Stage 1 Road Safety Audit

South Circular Rd to Bishops Quay Cycle Lane, Limerick City

On behalf of Limerick City & County Council

September 2022

3.2.27 Access to Oriental Supermarket

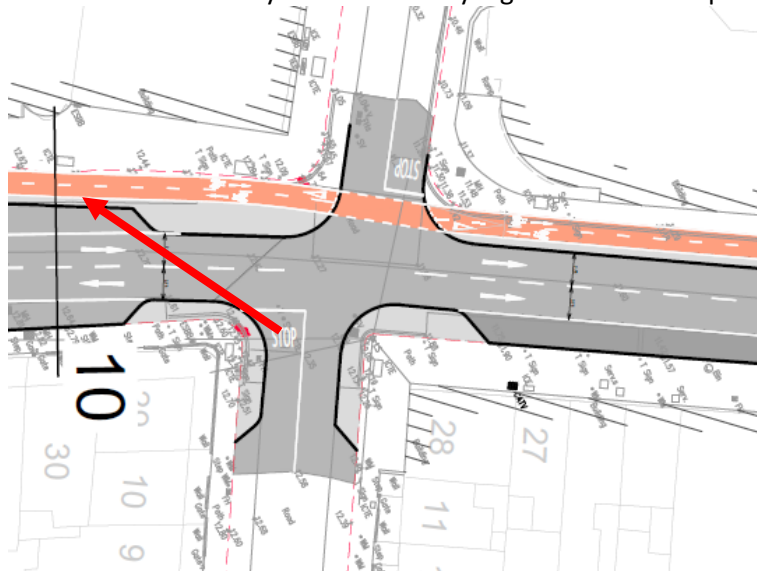
Problem: There are a number of car parking spaces to the front of the oriental supermarket. These users were observed driving forwards into the spaces and reversing back onto Henry Street. The provision of the cycle facility will result in the user reversing back over the cycle facility.

Hazard: Impact with cyclists may result.

Recommendation: Omit the perpendicular parking bays.

The recommendation has been rejected by the design team.

3.2.28 Lower Hartstonoge Street

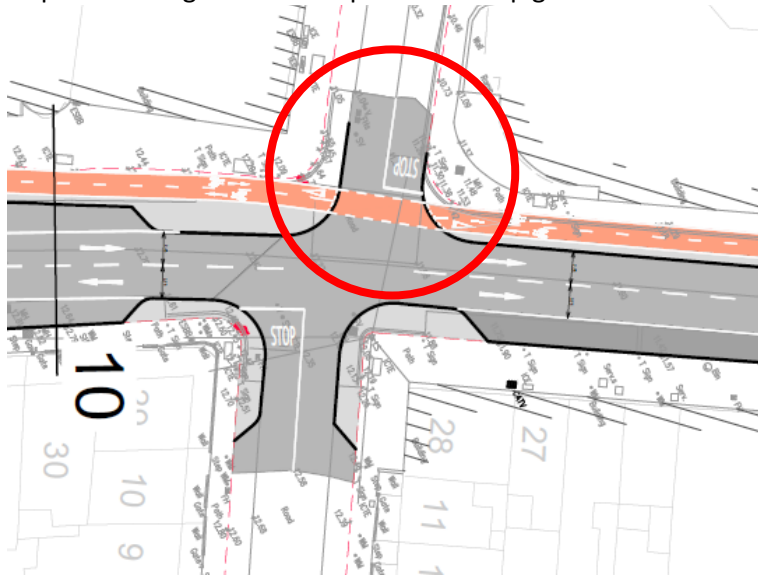
Problem: Drivers exiting Lower Hartstonoge Street and entering Mount Kenneth Place may have their view of northbound cyclists blocked by high sided vehicles parked in the Henry Street parking bay.

Hazard: Impact with cyclists crossing Mount Kenneth Place may result.

Recommendation: Omit some of the problematic parking bay on Henry Street.

The recommendation has been agreed by the design team.

3.2.29 Mount Kenneth Place - Gradient

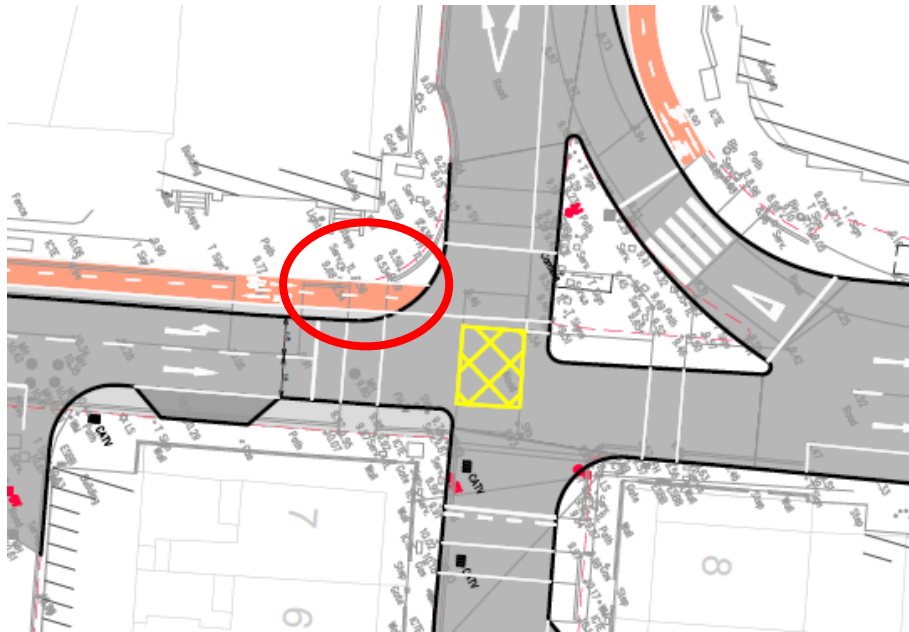
Problem: Mount Kenneth Place has a steep gradient to the Shannon. The relocation of the stop line required exiting traffic to stop on this steep gradient.

Hazard: The driver may roll backwards or stall upon attempting to exit the junction.

Recommendation: Amend the junction arrangement to provide a dwell area for traffic exiting Mount Kenneth Place.

The recommendation has been agreed by the design team.

3.2.30 Henry Street – Push Button Crossing at Junction of Lower Mallow Street

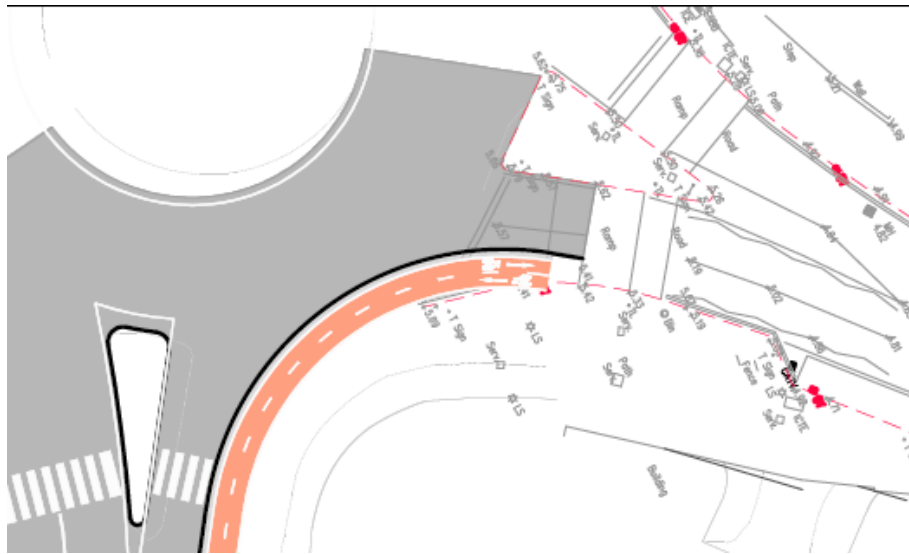
Problem: The cycle facility crosses through the pedestrian crossing. Pedestrians are likely to stand in the cycle lane while waiting for the green man signal.

Hazard: Pedestrian / cyclist impacts may result.

Recommendation: Terminate the dedicated cycle facility short of the pedestrian crossing(s) at the junction.

The recommendation has been agreed by the design team.

3.2.31 End of Cycle Facility – Bishops Quay

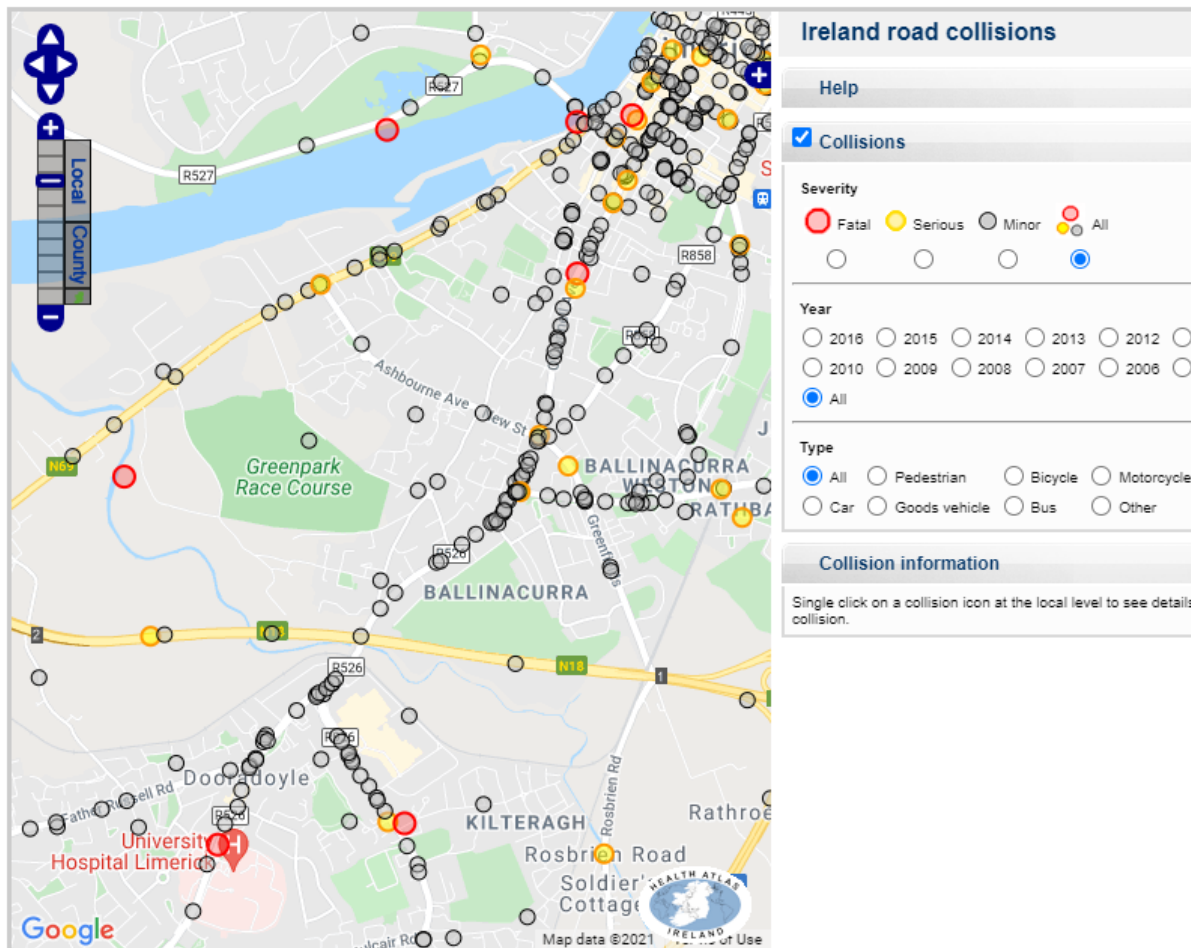
Problem: The cycle facility abruptly ends near the pedestrian crossing on Bishops Quay. No guidance is given to the cyclist on how to continue their journey in any direction.

Hazard: The cyclist may make sudden and unexpected directional choices. Impact with pedestrians or motorised vehicles may result.

Recommendation: Provide suitable design(s) for permitting cyclists to continue their journey to all roads at this junction.

The recommendation has been agreed by the design team.

4.2.1 Cyclists direction

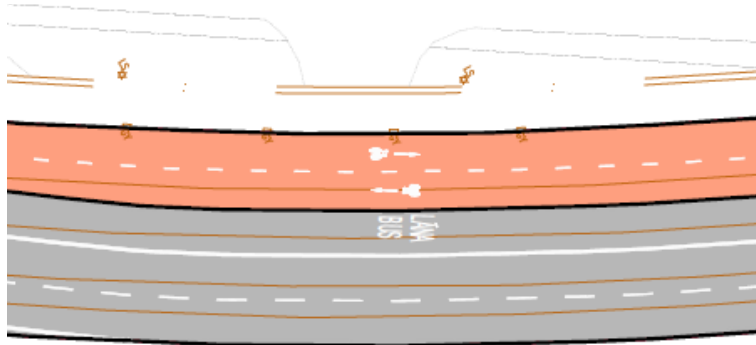
Problem: The proposal generally indicates the cyclists nearest the carriageway is travelling in the opposite direction to the adjacent motorists.

Hazard: Errant cyclists who may enter the carriageway are at risk of head-on collisions with motorised vehicles.

Recommendation: Amend the design such that the cyclist adjacent to the carriageway is travelling in the same direction as the adjacent motorist.

4.2.2 Road Markings and Signage

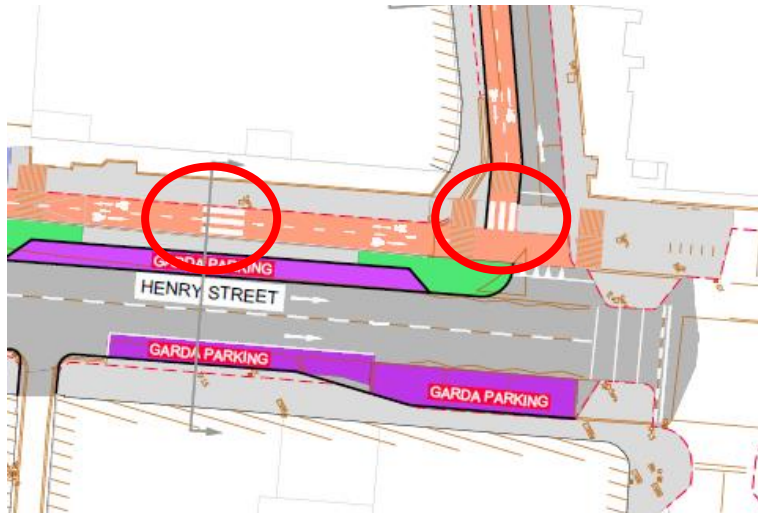
Problem: Although the drawings indicate the signage references numbers, the signage and road markings shown on the drawings do not appear to be complete.

Hazard: Insufficient or misleading signage may result in user confusion and potential impact between user groups.

Recommendation: Undertake a full review of the signage and road markings in advance of undertaking the Stage 2 Road Safety Audit.

4.2.4 Ladder Paving / Road crossings

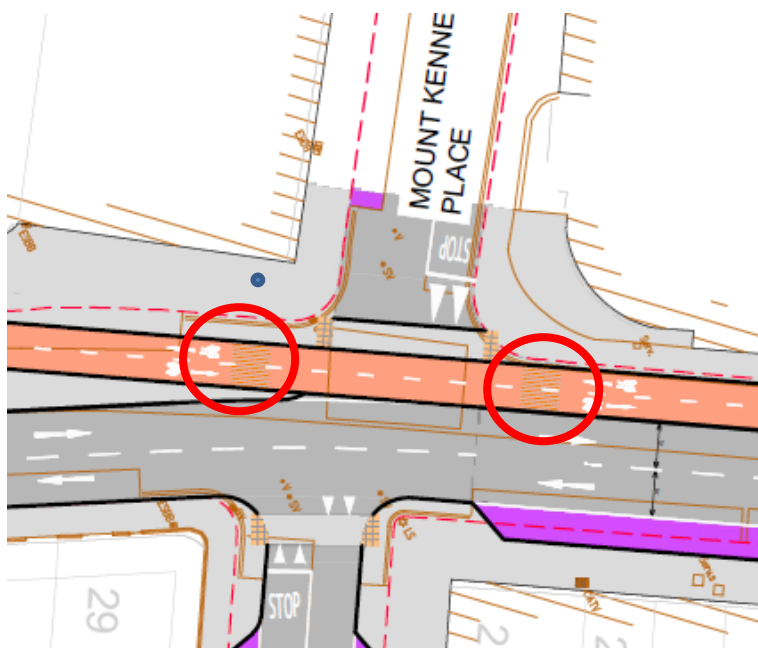
Problem: The arrangement of ladder paving being confined to the cycle path is non-standard and may be confusing. Ladder paving is normally provided along the route of the cycle path and across the adjacent footpath at the termination of the cycle path.

Hazard: Sight impaired users may errantly enter the cycle path in the area of the junction, in between the ladder paving units. The user may be stuck by cyclists.

Recommendation: Maintain a level change between the cycle path and footpath throughout and omit the ladder paving.

4.2.5 Blister tactile paving layout.

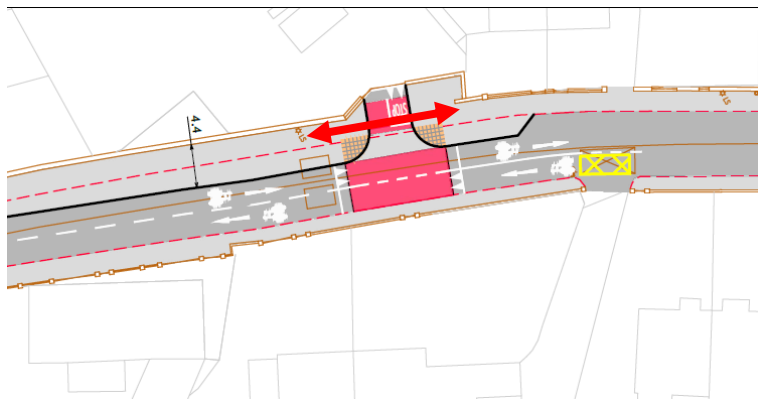
Problem: Sight impaired users often use the rear edge of the footpath / boundary walls to assist in their travel. the proposed blister paving at the junctions does not extend to the probable desire line for sight impaired users.

Hazard: Sight impaired users may errantly step into the carriageway into the path of oncoming traffic.

Recommendation: Amend the tactile layout to provide suitable tactile for the intended users and amend the associated road markings to suit.

4.2.6 Junction priority

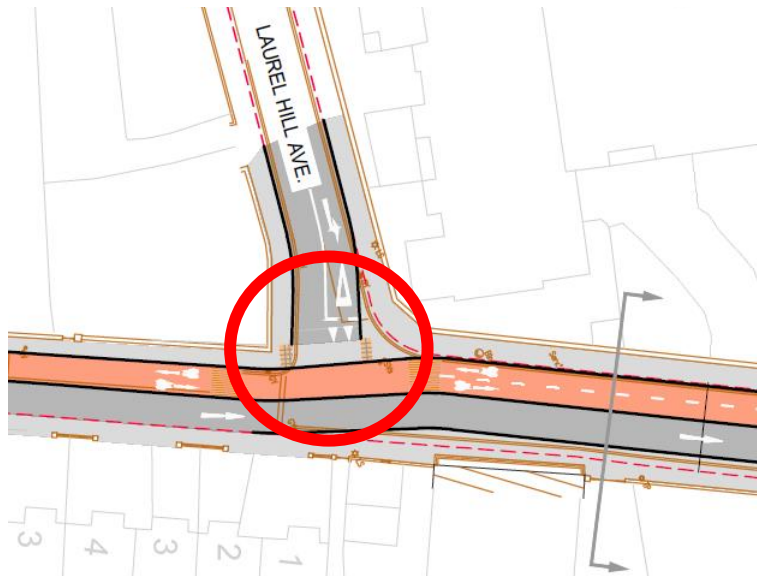
Problem: There are a number of junctions where the footpath surfacing material is carried through the junction and the minor road markings are set back, thereby indicating priority is given to the pedestrian. However tactile paving is also provided on the footpath.

Hazard: Sight impaired users encountering the blister paving are likely to believe they are required to wait for motorists to clear the junction prior to proceeding to cross the road. Confusion between motorists and pedestrians may result in collisions between the users.

Recommendation: Omit the tactile paving, ensure no kerb face is provided on the route of the pedestrian and ensure signage / road markings adequately inform the motorist that pedestrians have priority.

4.2.7 Zebra Crossings

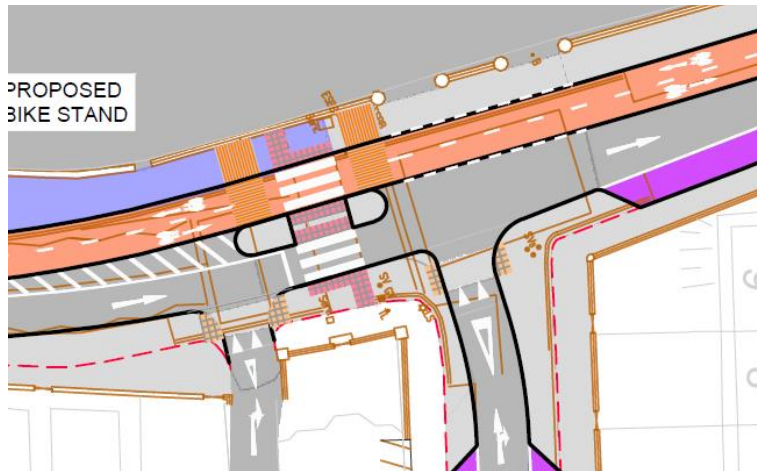
Problem: There are proposed zebra crossings within the scheme that are indicated as two separate crossings, one for the cycle path and a separate crossing for the carriageway, with a small refuge in between.

Hazard: Sight impaired users may experience difficulty in understanding the crossings. Additionally large volume of pedestrians may overspill the central refuge and be subject to vehicle strikes.

Recommendation: Provide a single stage crossings of both the carriageway and cycle path.

4.2.8 St Nesson's Road / Ballinacurragh Road

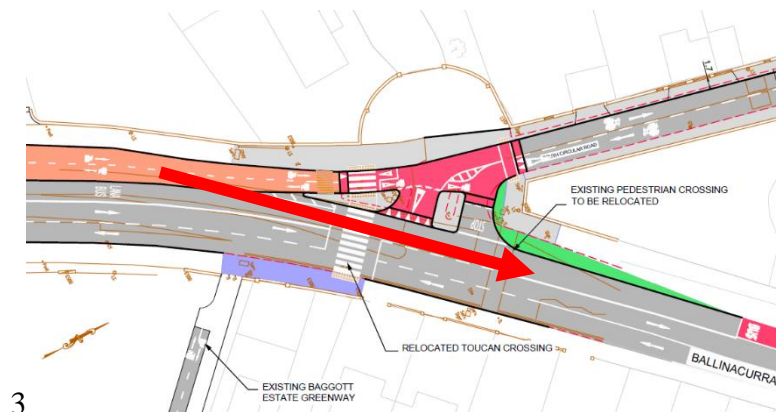
Problem: The existing southbound cycle lane to the east of Ballinacurragh Road is not shown on the drawings. It is likely the majority of southbound cyclists will make use of this lane and not the proposed lane to the west of the road. Northbound cyclists are likely to become complacent and make use of the full cycle facility to the west of the road.

Hazard: Occasional southbound cyclists who decide to make use of the facility on the western side of the road are at risk of impact from opposing cyclists.

Recommendation: Omit the southbound facility to the west of the road and make provision for cycles exiting South Circular Road to access the existing cycle lane.

4.3.2 South Circular Road / Ballinacurragh Road Junction

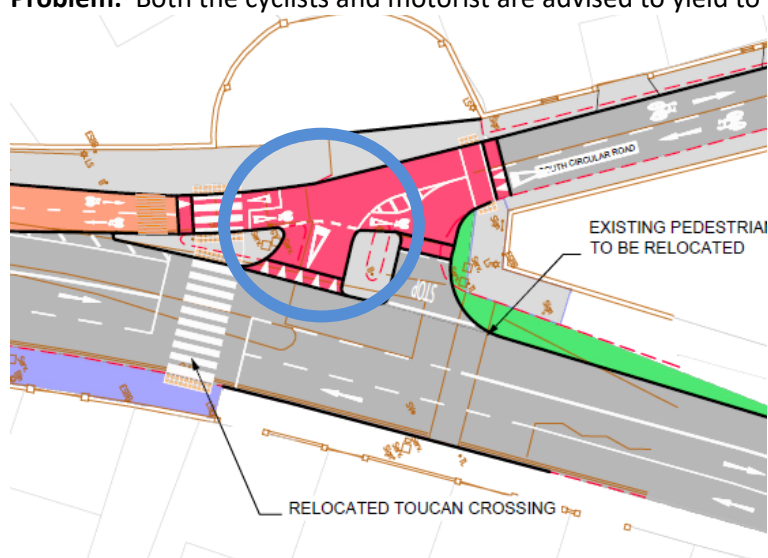
Problem: Both the cyclists and motorist are advised to yield to each other at this junction.

Hazard: Motorists who yield to the cyclists are at risk of creating a tail back onto the Ballinacurragh road with the resultant risk of rear end shunts.

Recommendation: Omit the road marking for the motorist and offer this user priority to continue through the junction.

4.3.3 Ballinacurragh Road motorists turning right into South Circular Road

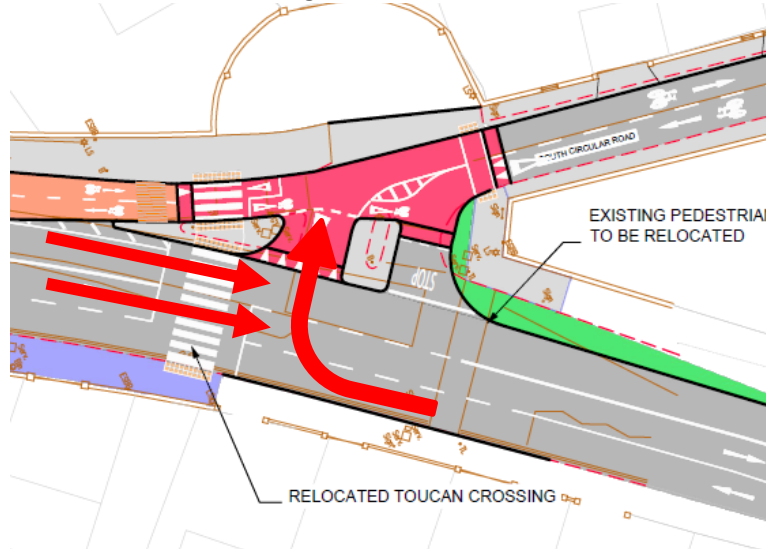
Problem: Motorists wishing to turn right into South Circular road are required to cross two lanes of northbound Ballinacurragh Road traffic.

Hazard: Queuing high sided vehicles in the offside lane may shield smaller and faster moving smaller vehicles in the nearside lane. The right turner may commence their turn and impact with vehicles in the bus lane.

Recommendation: Ensure adequate visibility between all road users is provided.

4.3.4 Ballinacurragh Road motorists turning left into South Circular Road

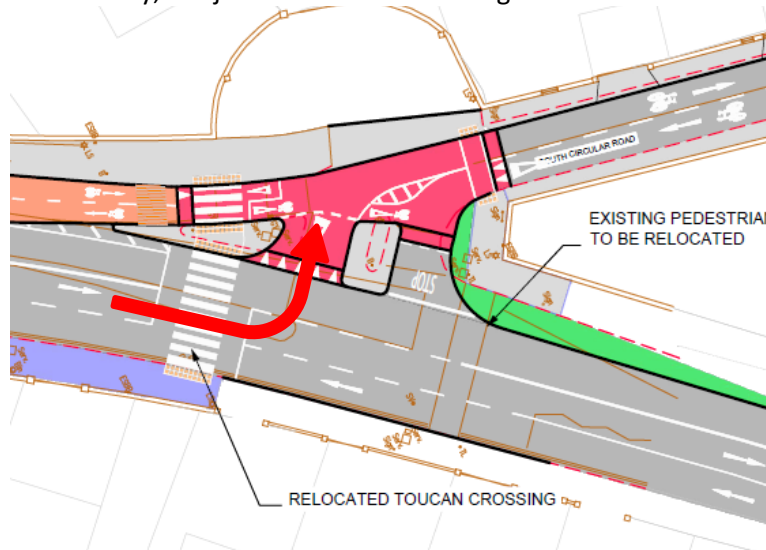
Problem: Motorists wishing to turn left into South Circular Road are required to cross the bus lane. Additionally, the junction radius seems tight.

Hazard: The left turning motorists may be stuck by an approaching vehicle in the bus lane. Additionally, the user may strike the kerb.

Recommendation: Amend the road markings to enable left turning traffic to occupy the nearside lane. Undertake swept path analysis to ensure the junction radii is adequate.

4.3.5 Greenpark Avenue Junction

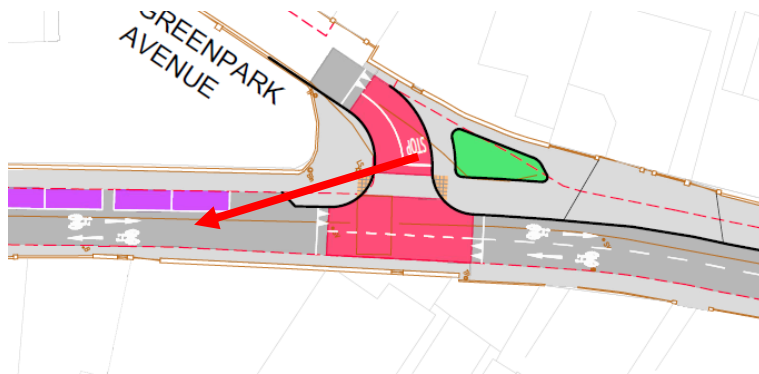
Problem: Cars parked in the parking bays to the west of the junction may park outside of the indicated bays and closer to the junction.

4.3.6 Ashbourne Av. / South Circular Road junction - Pedestrians

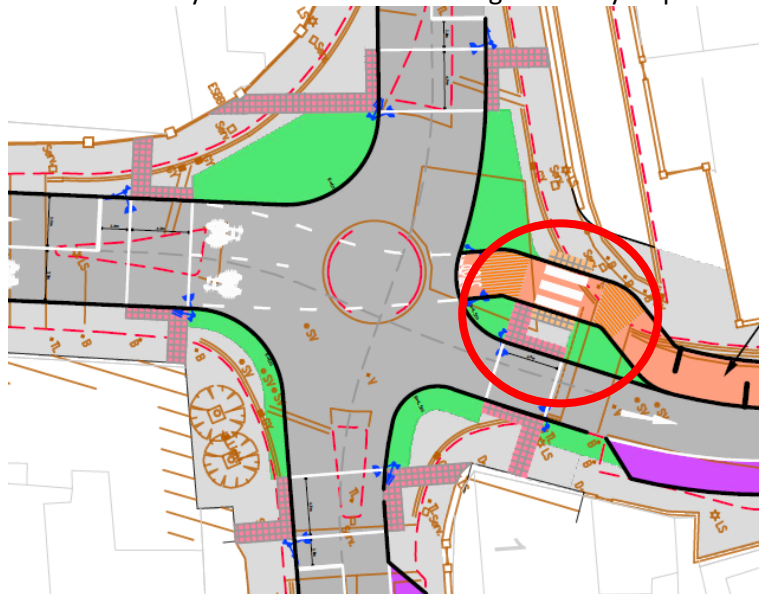
Problem: Signalised crossing points are offered to the pedestrian for crossing the main carriageway, but there is only an uncontrolled crossing for the cycle path.

4.3.7 Ashbourne Ave / South Circular Road junction – Cyclists

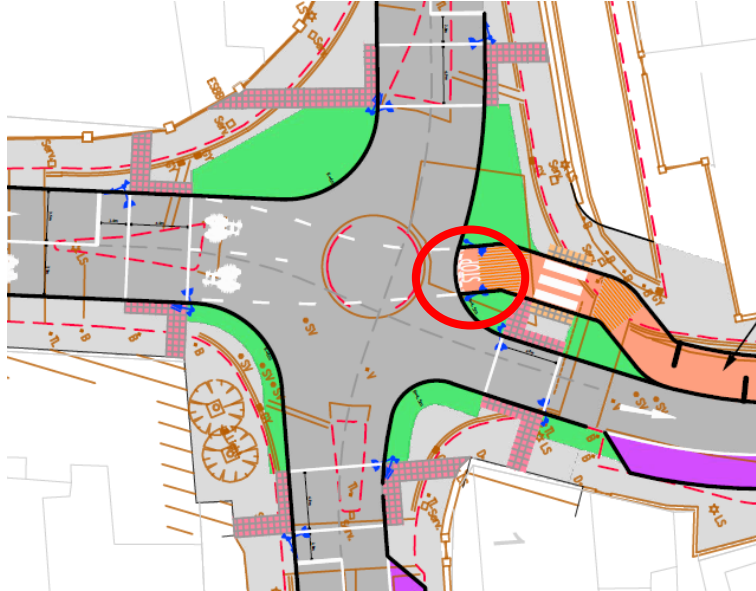
Problem: Cyclists are expected to enter the signalised junction without sight of the signals.

Recommendation: Provide a dedicated signal stage for the cyclist.

4.3.8 South Circular Road – Staggered barrier

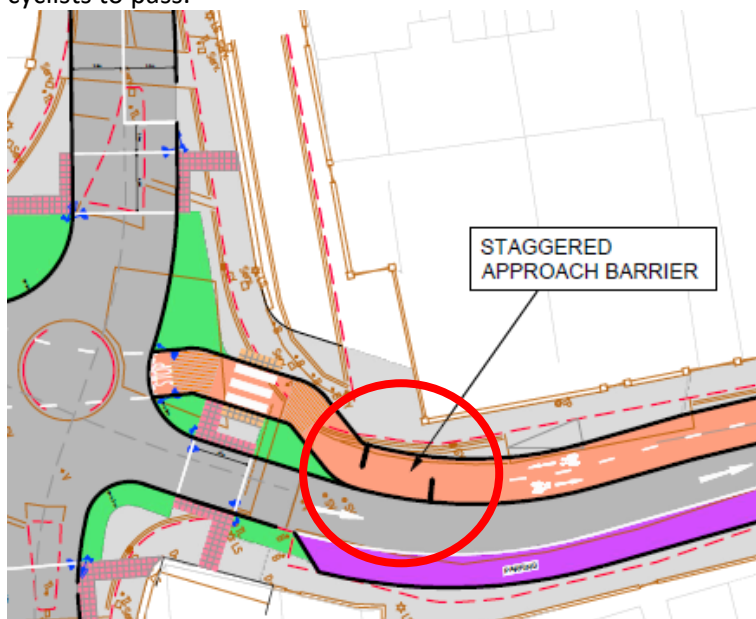
Problem: The provision of the staggered barrier results in inadequate cycle path width for opposing cyclists to pass.

Recommendation: Provide road markings / signage giving priority to the northbound cyclist.

| TO BE COMPLETED BY DESIGNER | | | | TO BE COMPLETED BY AUDIT TEAM LEADER |
|--------------------------------------|---------------------------|---------------------------------------|--|---|
| 4.3.8 | Yes | No | Remove staggered barriers. | Yes |

4.3.9 South Circular Road / Lifford Park junction

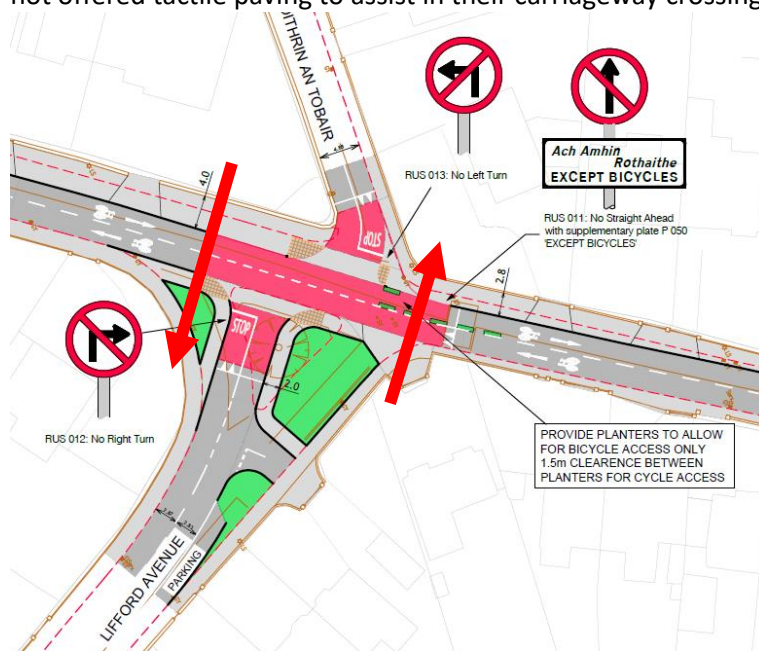
Problem: Sight impaired pedestrians who wish to cross from Boithrin An Tobair to Lifford Avenue are not offered tactile paving to assist in their carriageway crossing.

Recommendation: Provide suitable blister paving and dropped kerbs at a suitable carriageway crossing location.
